ORDINANCE NO. 5089

AN ORDINANCE APPROVING A LANDSCAPE PLAN AND STREET TREE PLAN FOR THE BAKER CREEK NORTH SUBDIVISION

DECISION, CONDITIONS, FINDINGS OF FACT AND CONCLUSIONARY FINDINGS FOR THE APPROVAL OF A LANDSCAPE PLAN AND STREET TREE PLAN FOR THE BAKER CREEK NORTH SUBDIVISION

DOCKET: L 12-19 (Tree Removal, Landscape Plan and Street Tree Plan)

Figure 4. Proposed Street Tree Plan

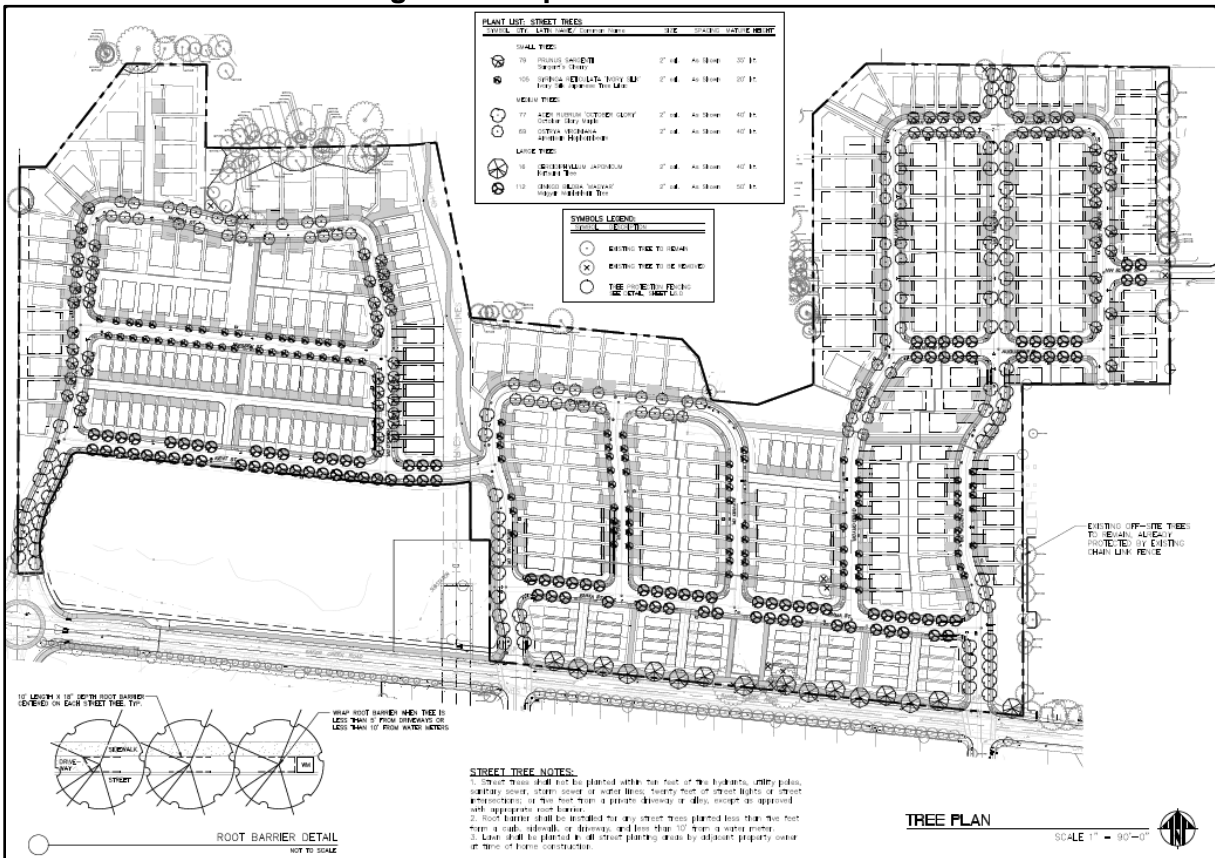
- McMinnville Engineering Department
 - McMinnville Municipal Code Section (MMC) 12.20.030(B) requires that the maximum width of driveways for properties with street frontage between 20 and 75 feet wide shall be not more than 40% of the frontage. The proposed lot configurations for SFD-70, SFD-60, and SFD-40, as shown on page EXH-5, do not meet the Ordinance standard. Additionally, a review of the Site Plan (SP) sheets indicates that the driveways for lots 117, 130, 131, 132, 202, 203, 224, 225, 228 and 271 do not comply with the Ordinance standard.

- MMC Section 12.20.070 indicates that if a driveway is constructed or installed on a corner lot, such driveway shall not be built closer than 30 feet from the point of intersection of the two curb lines projected ahead. A review of the Site Plan (SP) sheets indicates that the driveway for lot 35 may not comply with that standard.

- Recognizing that street tree plans are reviewed and approved at a later date by the Planning Department and the Landscape Review Committee, we did note that several of the proposed tree locations will need to be adjusted due to probable conflicts with utilities and due to street sight distance concerns.

FINDING: SATISFIED WITH CONDITIONS OF APPROVAL #15 and 17. The Street Tree Plan has been requested for concurrent review and approval with the Planned Development and Subdivision applications. Approval of the Planned Development and Subdivision would allow variances to lot sizes and widths. The Street Tree Plan illustrates the proposed lot layout, along with proposed building envelopes, driveways, and utility locations. The applicant is requesting as part of the planned development approval street tree spacing that varies from the standards of the code as shown on the drawing L1.0 Street Tree Plan. In higher density developments lot frontage decreases and frequency of driveways and utilities increase, creating conflicts that require greater spacing between street trees than outlined in the code. The applicant notes that the planned development compensates for the increase in spacing in the following ways:

5. That only the 17 existing trees identified for removal on Drawing L1.0 Street Tree Plan shall be approved for removal.
6. That landscaping be provided for Sewage Pump Station Tract 'G'. Landscaping shall be provided at an amount equal to or greater than 25 percent of the gross area of the tract, and shall provide screening of the pump station structure from surrounding properties.

- iv. *Ostrya virginiana* (American Hophornbeam)
 - v. *Prunus sargentii* (Sargent Cherry)
15. That street trees in addition to those shown on the Street Tree Plan dated 11/18/2019 shall be provided in the following locations, unless a utility is present that creates a setback requirement:

19. Where street trees are planted in the approximately 10 foot long planter strips between driveways on neighboring lots, root barrier protection shall be provided around the perimeter of the entire planting strip to a minimum depth of eighteen (18) inches.

20. Where street trees are planted in any location less than 10 feet from a water meter, root barrier protection shall be provided along the sidewalk and curb as required by condition #16, and root barrier protection shall also be provided immediately adjacent to the water meter between the sidewalk and curb to a minimum depth of eighteen (18) inches.

Pump Station 'Tract G':

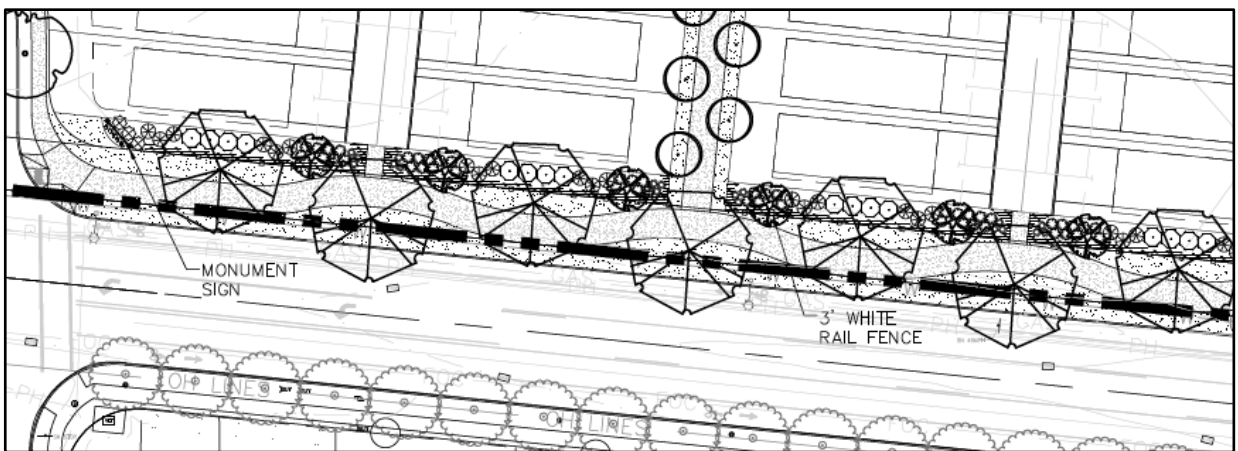
Landscaping was not proposed for Tract G at the intersection of Charles Street and Alfred Drive, where a sewer pump station is located. Tract G is adjacent to residential lots 60, 109, and 110, and is across the street from lots 49, 111, and Open Space Tract F. There is no screening or buffering of the pump station from the adjacent residential uses. A condition of approval requiring landscaping to screen and buffer the sewage pump station has been included.

CONDITION FOR FINDING: That landscaping be provided for Sewage Pump Station Tract ‘G’. Landscaping shall be provided at an amount equal to or greater than 25 percent of the gross area of the tract, and shall provide screening of the pump station from surrounding properties.

Open Space 'Tract I':

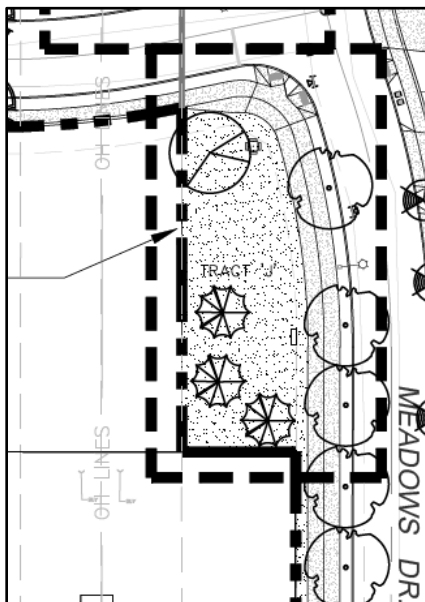
Based on comments from McMinnville Water & Light, trees surrounding the electric substation should be limited in height to 25 feet. A condition is included limiting the height of any trees located in Open Space Tract I to a maximum mature canopy height of 25 feet.

Open Space 'Tract J':

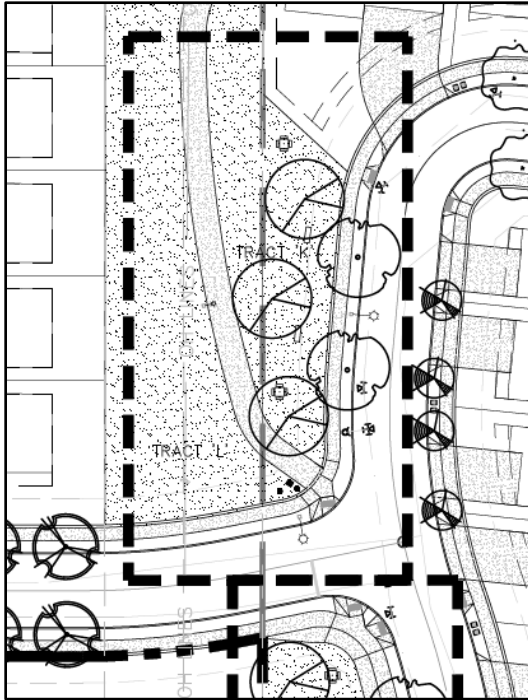
Douglas Fir trees can grow to approximately 100 feet tall and 30 feet wide, and Sunburst Honey Locust grow to approximately 40 feet tall and wide. Based on comments from McMinnville Water & Light, trees surrounding the electric substation should be limited in height to 25 feet. Additionally, trees adjacent to the transmission easement should be limited in height 40 feet and located such that no canopy encroaches into the transmission easement. A condition is included limiting the height of any trees in Open Space Tract J adjacent to the electric substation to a maximum mature canopy height of 25 feet, and no tree in Tract J shall

exceed a maximum mature canopy height of 40 feet or be located such that no canopy encroaches into the transmission easement.

Open Space 'Tract K':

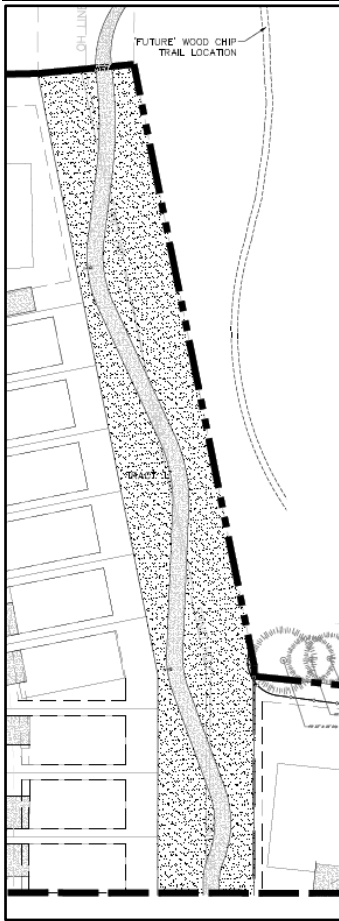
Sunburst Honey Locusts grow approximately 40 feet tall and wide. Based on comments from McMinnville Water & Light, trees in Tract K should be located such that no canopy encroaches into the transmission easement. A condition is included limiting the height of any trees in Open Space Tract K to a maximum mature canopy height of 40 feet and to locations such that no canopy encroaches into the transmission easement.

Open Space & Access Easement 'Tract L':

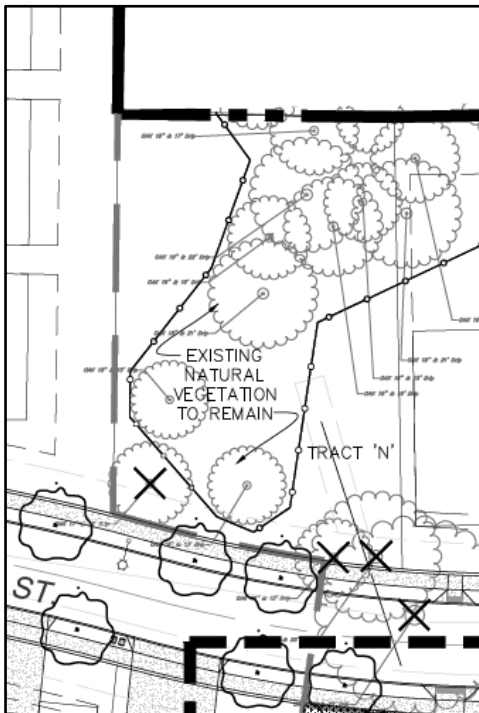
- Tract L: shows an offset 10' gravel pathway, and turf for a portion of the tract. The remaining portion is labelled as "existing grass field to remain", with a 10' gravel pathway. This is not similar to the existing BPA pathway design as per earlier discussion, and does not provide an accessible surface for pedestrians.

Additionally, no street trees should be located within the public right-of-way in the transmission line easement, where they would be in incompatible with electrical transmission lines overhead.
